PROJECT/LOCATION: H Rd, W of 3 D Systems *M^g - Sub. Prelim*

Proposal Preliminary Plan, North Crest Industrial Park

PP-2001-057 PRELIMINARY PLAN - NORTH CREST INDUSTRIAL PARK- H Rd, West of 3D Systems
Request for approval of a Preliminary Plat to subdivide 20 acres into 11 lots in an I-O (Industrial Office) zoning district.
Planner: Bill Nebeker

COMMENTS - For Review Agency Use Only

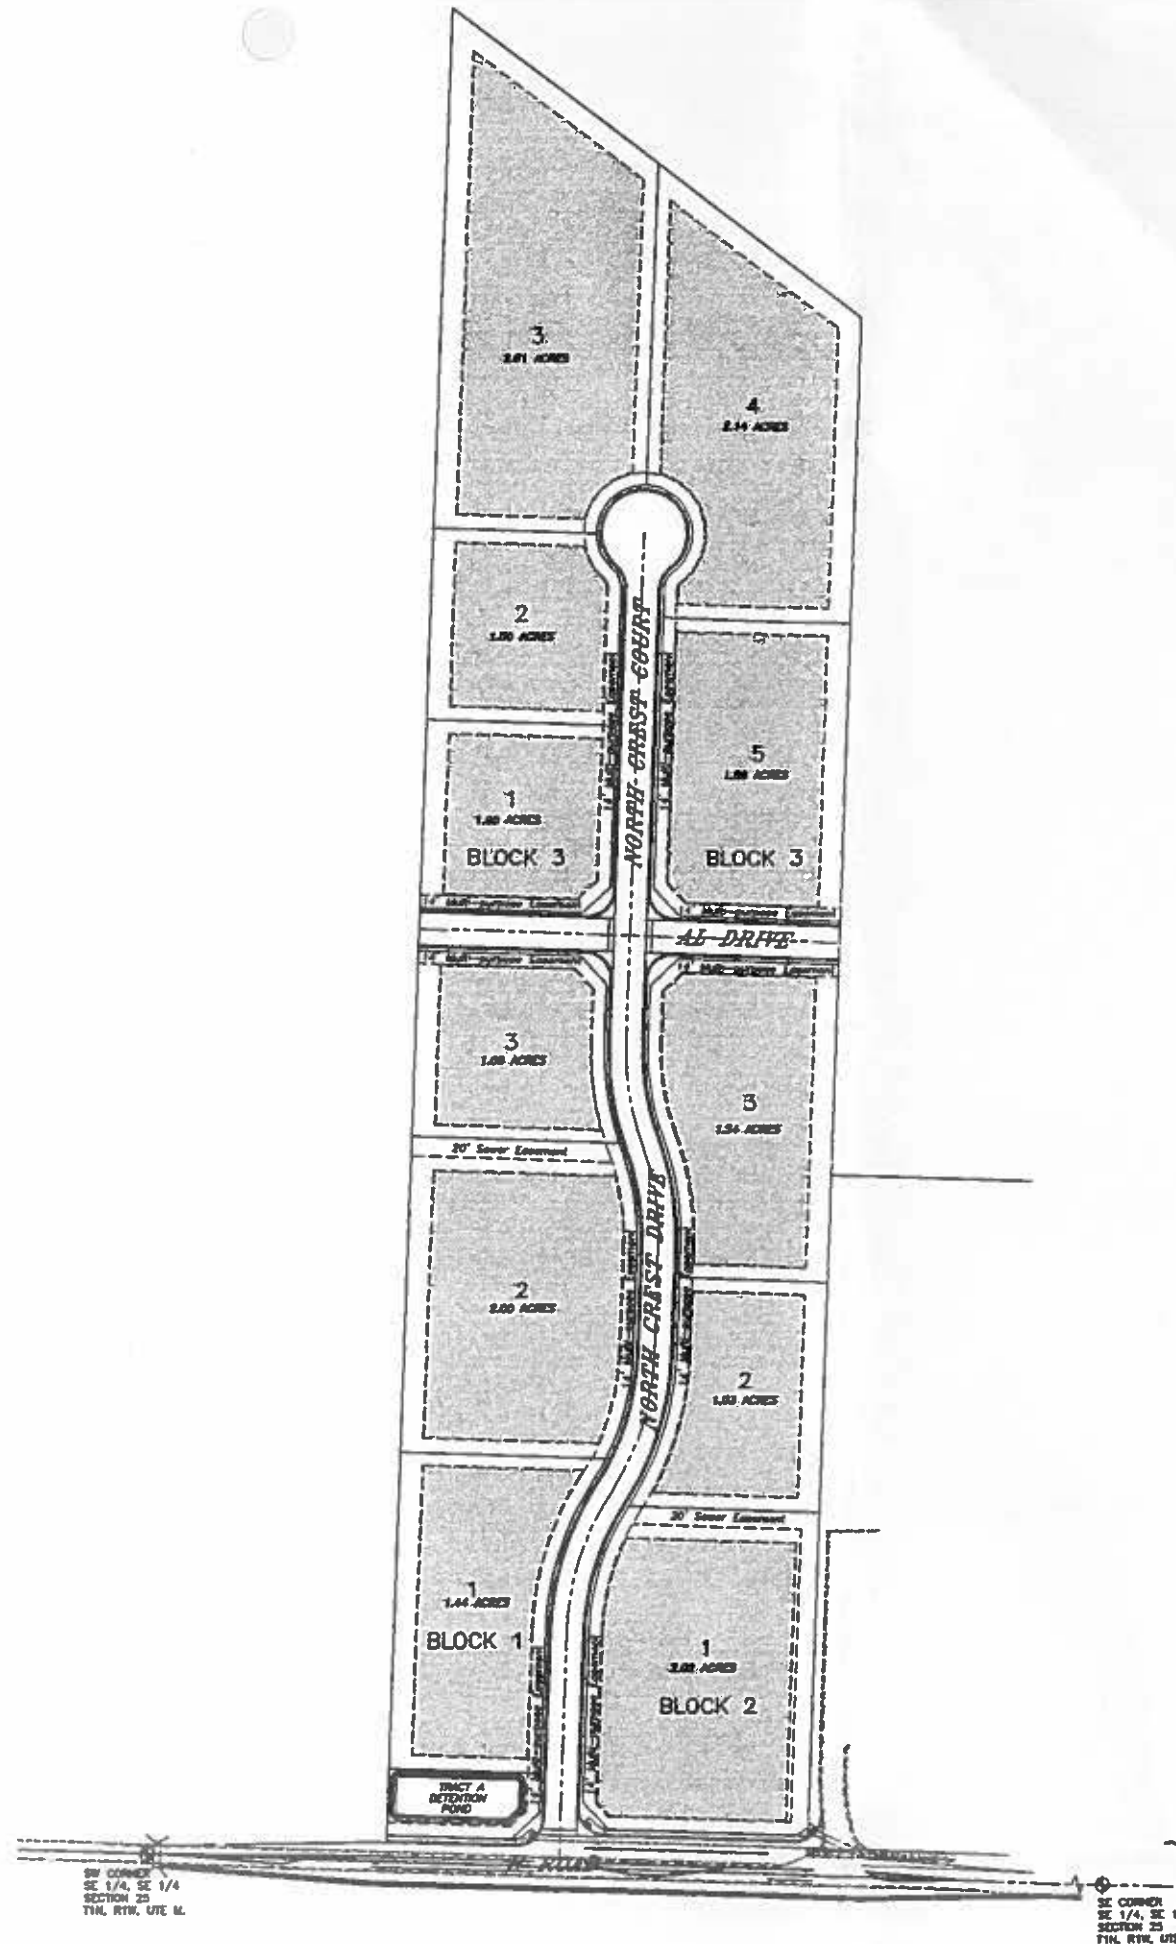
1.) MAY NEED EASEMENT ALONG EAST
SIDE OF PROJECT TO ALLESS EXISTING
UNDERGROUND POWER LINE. (3Ø)

INDUSTRIAL STREET SECTION

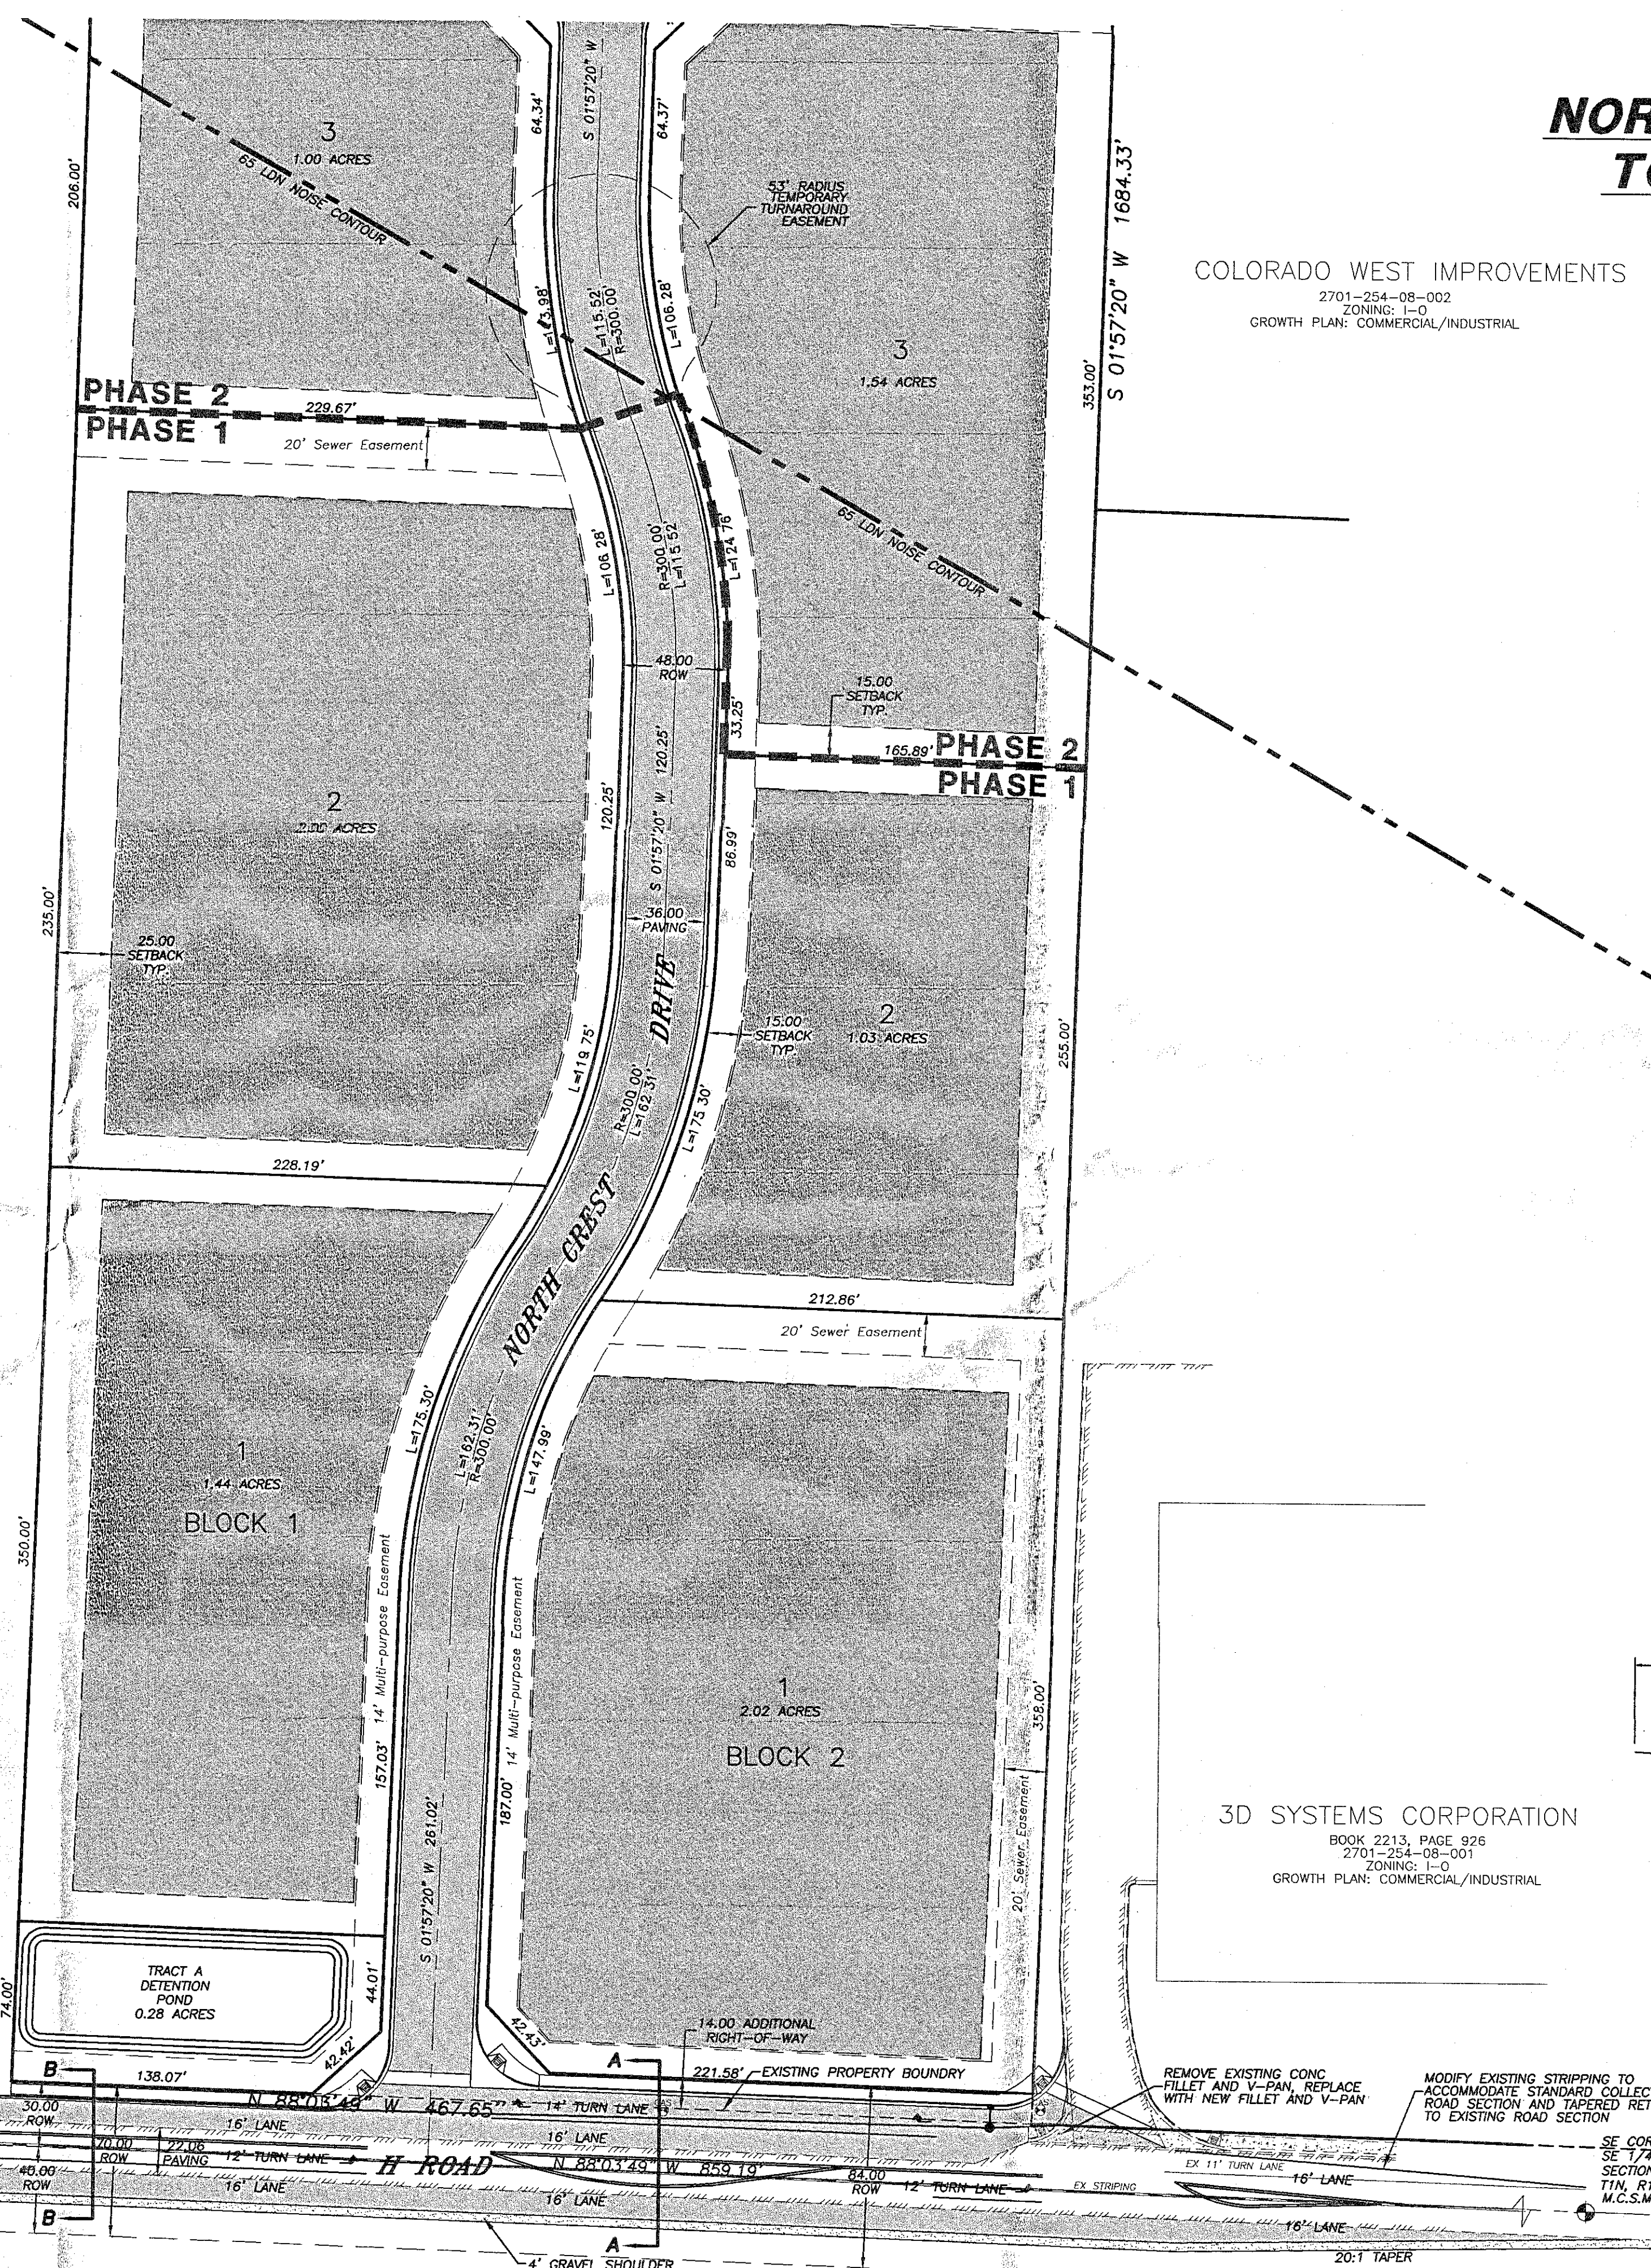
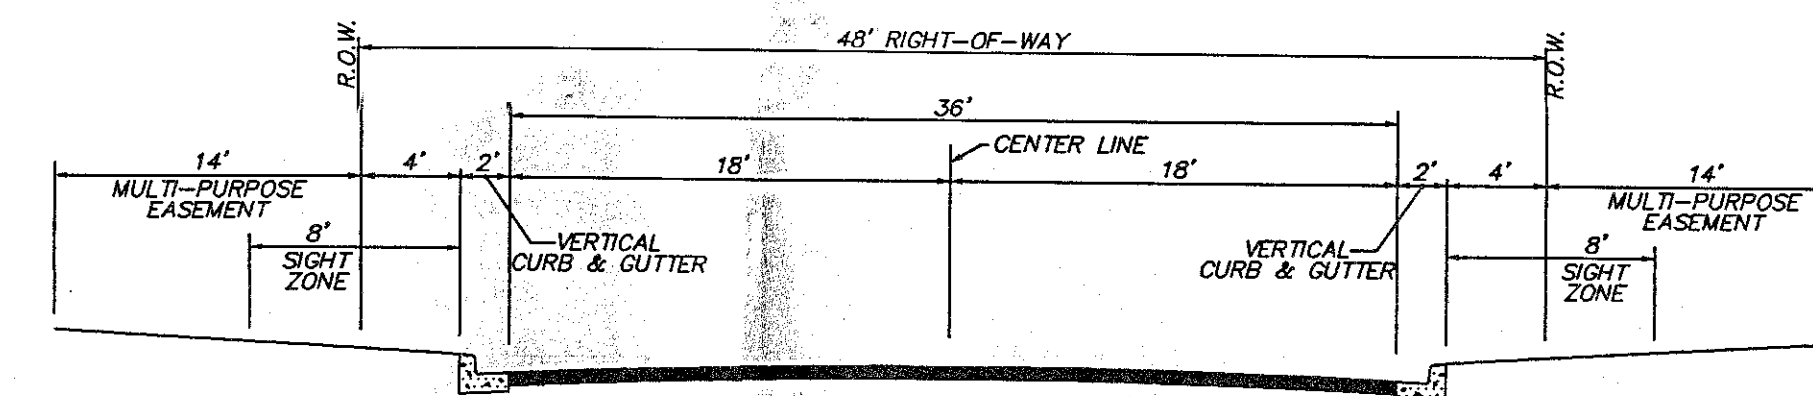
With the uses that are allowed in the I-O zone I believe the commercial street section that includes sidewalks is the more appropriate street section for North Crest Drive and Court. I will be including this as my review comment unless told to do so otherwise.
